ADDENDUM

ADDENDUM NO.: 02
PROJECT NAME: Kenwood Academy Link and Mechanical (Rebid)
PROJECT NO.: 05326
CONTRACT NO.: C1602R
DATE OF ISSUE: February 29, 2024

NOTICE OF CHANGES, MODIFICATIONS, OR CLARIFICATIONS TO CONTRACT DOCUMENTS

2 5'H OR 6'H ORNAMENTAL METAL SINGLE SWING GATE ELEVATION
1/2" = 1'-0"

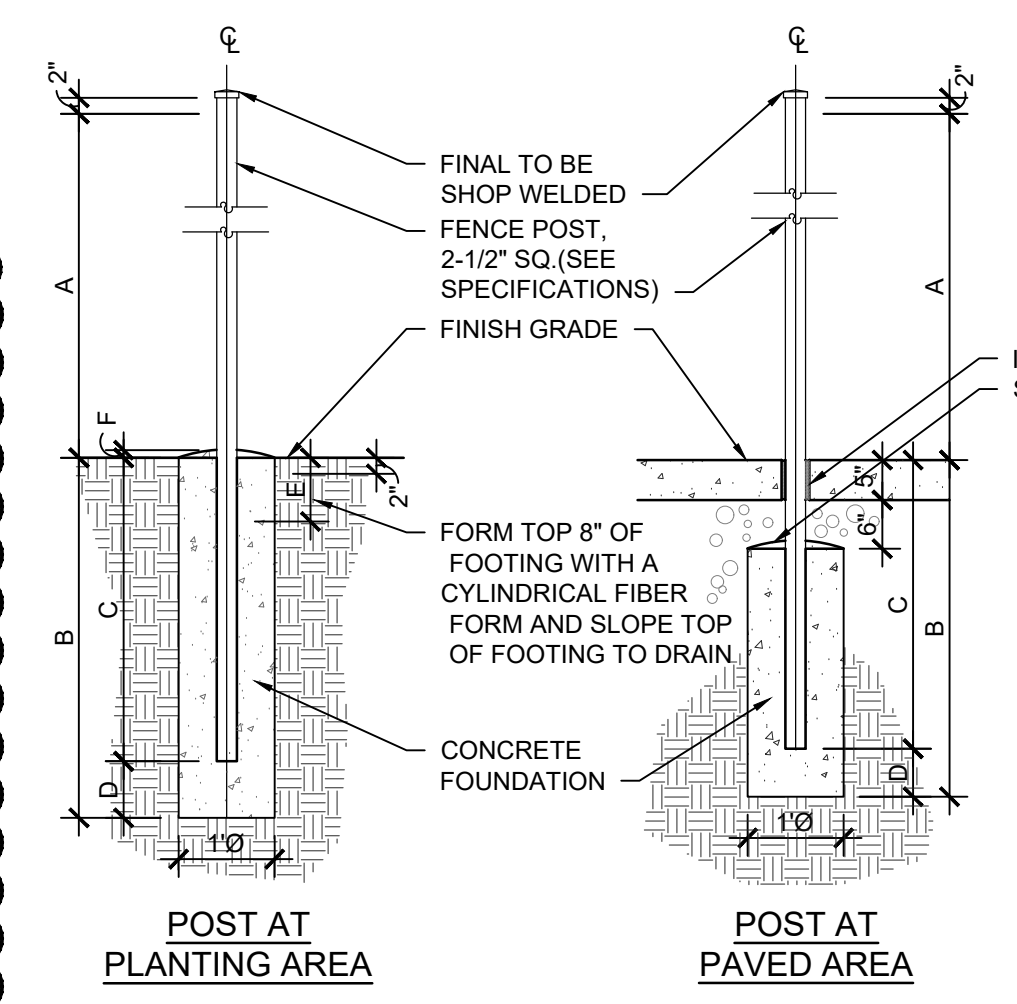
Change 7 L504 - FURNISHING DETAILS; **REVISED** to update detail 2/L504, Ornamental Metal Swing Gate Elevation

RFI-1. There is a man gate shown to be installed on landscape and civil drawings at the southeast corner of the track/field fencing; however, it was confirmed that this gate should not be included in the scope. Please advise.

Question: Provide new ornamental gate scope as indicated on sheets L104 and L504 revised and included in this addendum.

PBC Project Name: Kenwood Academy Link & Mechanical
PBC Contract No.: C1802R
Project No.: 05328
Title: ENLARGED PARTIAL PLAN - FIRST FLOOR

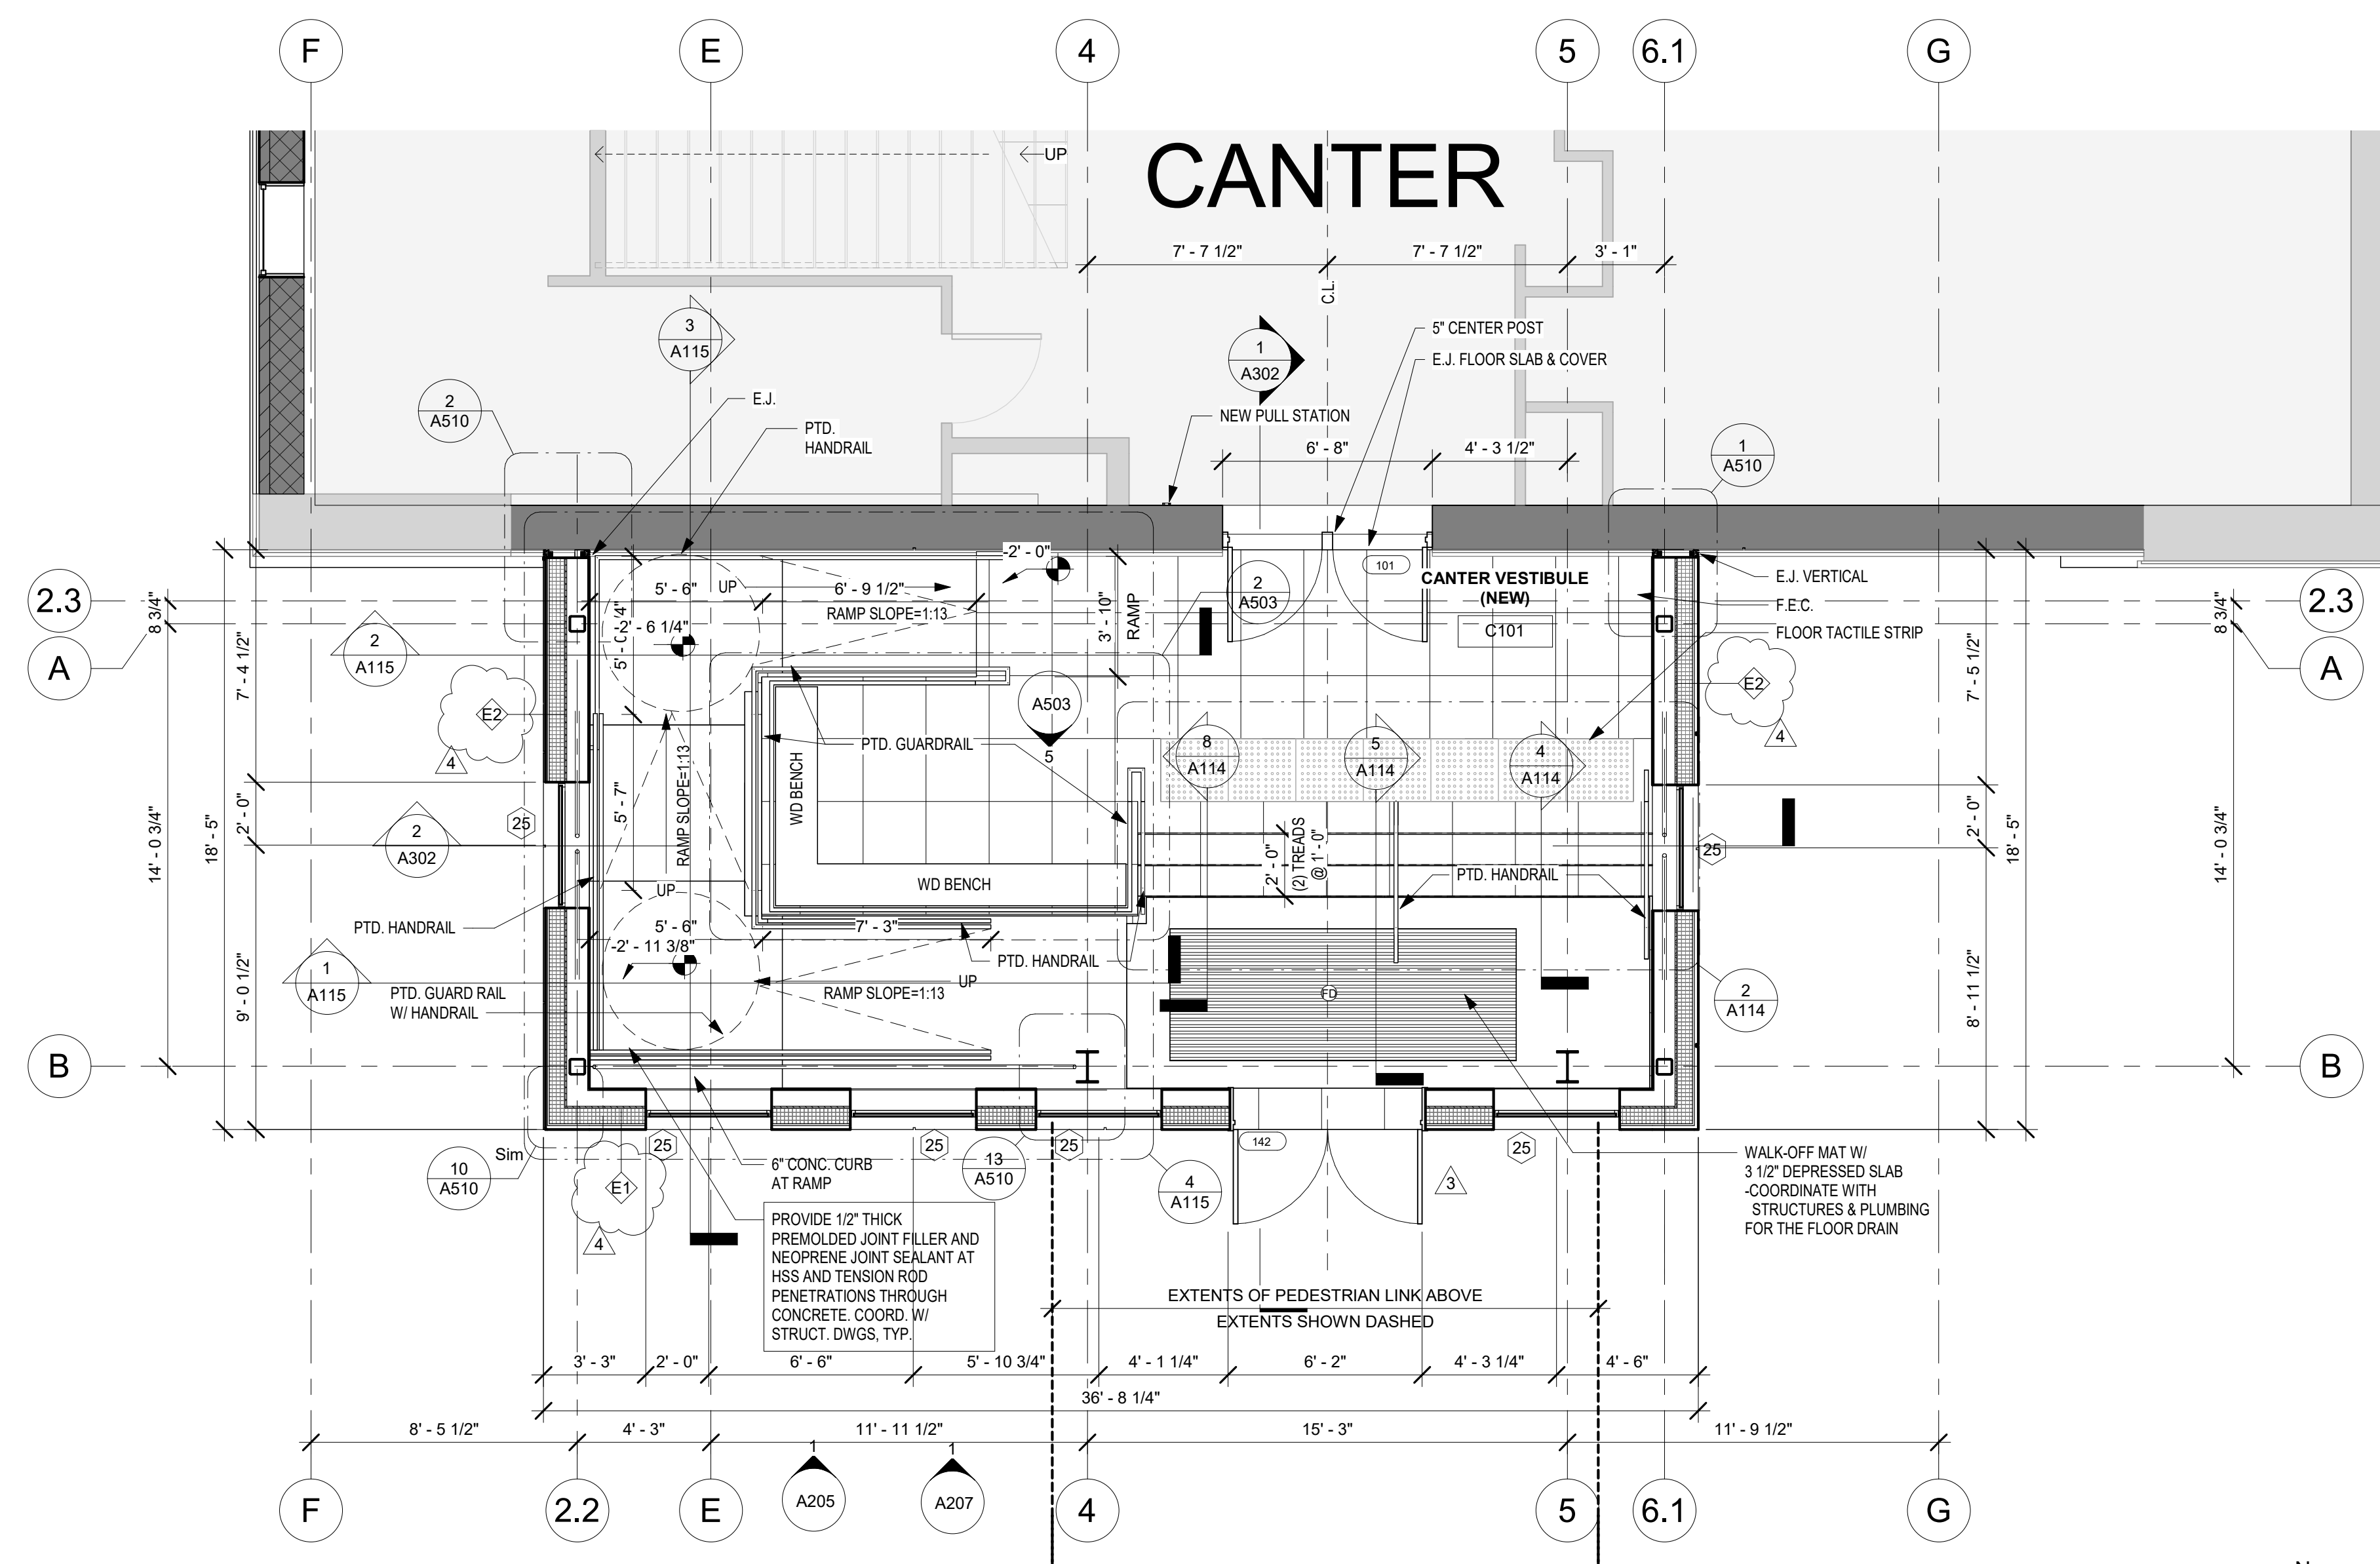
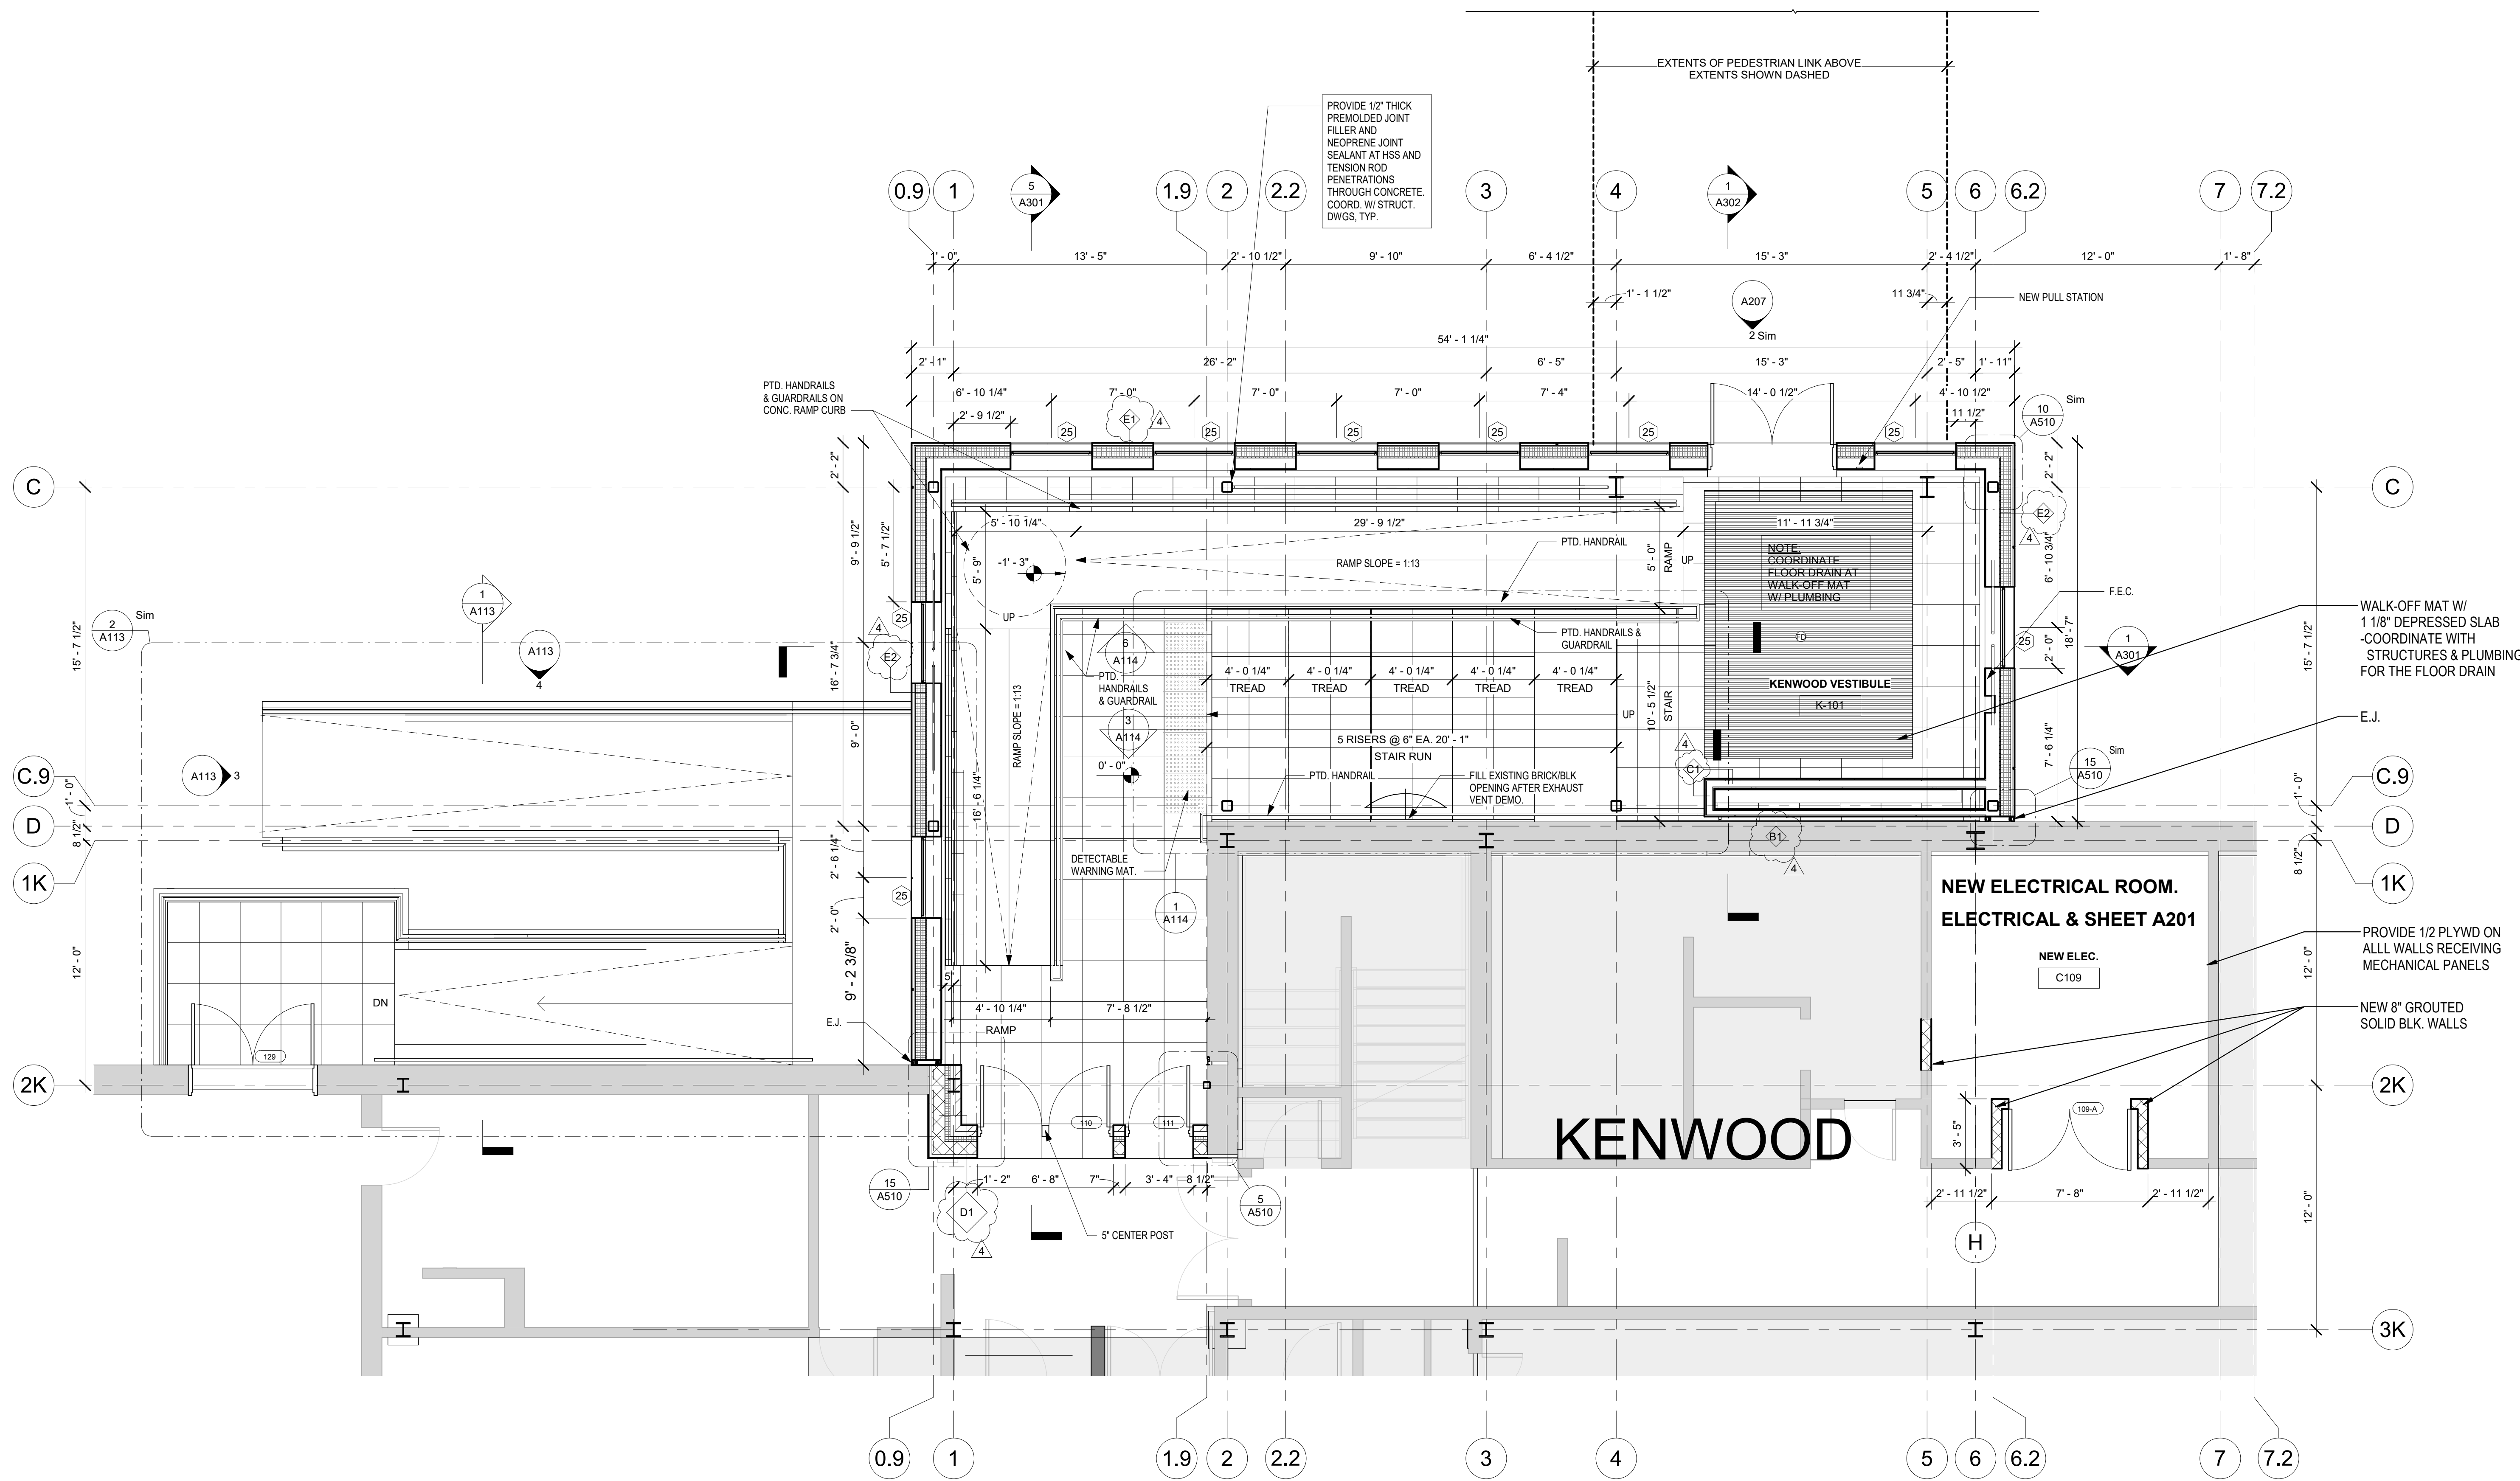
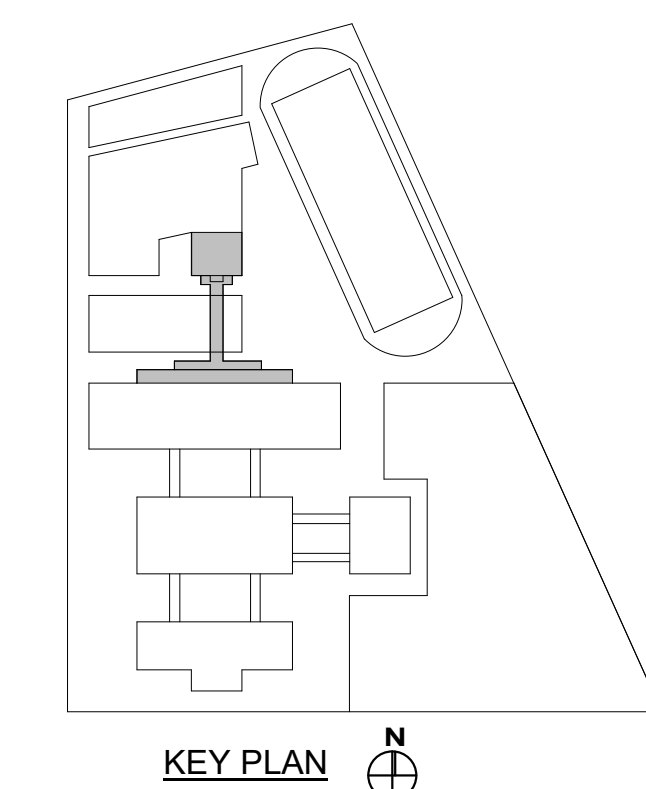
Change 8 A110 - ENLARGED PARTIAL PLAN 1st floor; **REVISED** to add and revise wall tags.

Question: (Regarding Partition Types) Please note that the exterior walls/partitions in the link are not identified by partition type. Some walls are 6" CFMF and others are 8" CFMF. Can you identify which walls 6" and/or 8" by a wall type?

Question: (Regarding Partition Types) To determine the depth of the solid surface sills 5 3/4" or 7 3/4" it would be helpful to know the stud size per wall type.

Response: [All exterior Wall Types are the same construction type. 8" metal studs have a 6" HSS structural column inside the wall. 6" metal stud walls do not have a column inside. Please refer to sheets A110, A111, and A605 revised and included in this addendum.](#)

Response: [E1 partitions to have 5 3/4" sill depth and E2 partitions to have 7 3/4" sill depth. Please refer to sheets A110, A111, and A605 revised and included in this addendum.](#)
